Service Bulletin

16-054

Timing Belt Chirps

AFFECTED VEHICLES

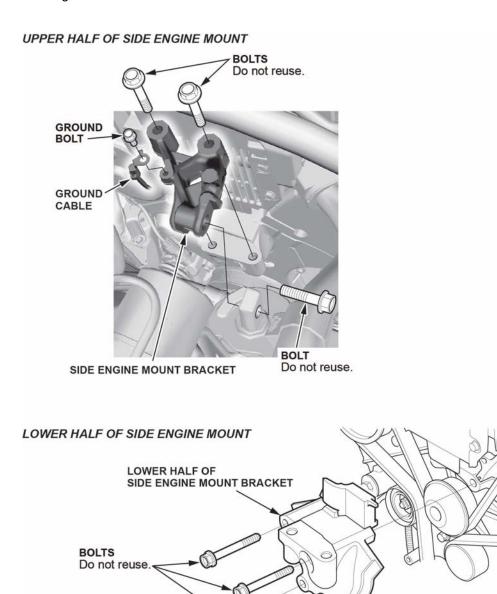
1. Make sure the engine is off, then try to insert a 0.95 mm feeler gauge between the top edge of the timing belt idler pulley and the back side of the side engine mount bracket that overhangs the pulley.

- If you can insert the feeler gauge between the timing belt idler pulley and engine mount bracket, go to step 4.
- If you cannot insert the feeler gauge, go to step 2.

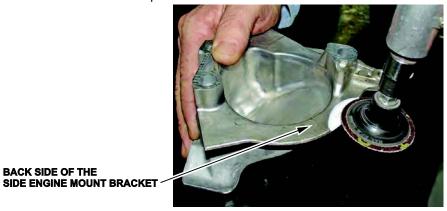
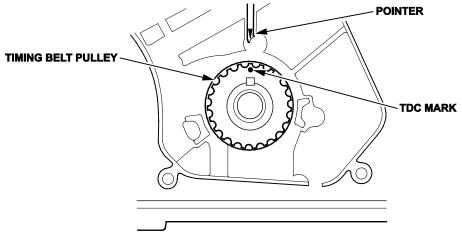
3. Using a die grinder with a 2-inch grinding disc, use the circular casting offset as a guide to grind the side engine mount bracket until the lip measures 2 mm in thickness.

NOTE: Use a vernier caliper or micrometer to confirm the amount of material removed.

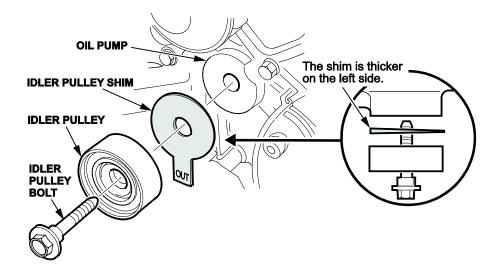
10. Place the idler pulley shim between the idler pulley and the oil pump housing, then loosely install the new idler pulley bolt with Hondalock 1 applied to its threads. Make sure you follow the instructions on the Hondalock 1 container.

NOTE: The shim is tapered from left to right. The word **OUT** is stamped into the tang and painted white. It should be readable after the shim is installed.

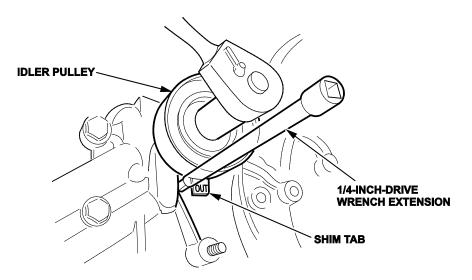
11. Install the new idler pulley bolt:

• Insert the square end of a ¼-inch-drive ratchet extension to keep the shim's tang in the correct position.

- Tighten the idler pulley bolt to 44 N-m (33 lb-ft).
- Bend the shim's tang slightly toward the oil pump housing to keep it away from the idler pulley.
- 12. Compress the timing belt auto tensioner.
 - Align the holes on the rod and timing belt auto-tensioner housing.
 - Use a hydraulic press to slowly compress the timing belt auto-tensioner. Insert a 2 mm (5/64 in) pin through the housing and the rod.

UPPER HALF OF SIDE ENGINE MOUNT

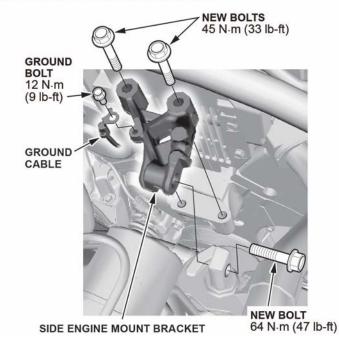
19. Install the side engine mount with the new bolts and torque them as shown.
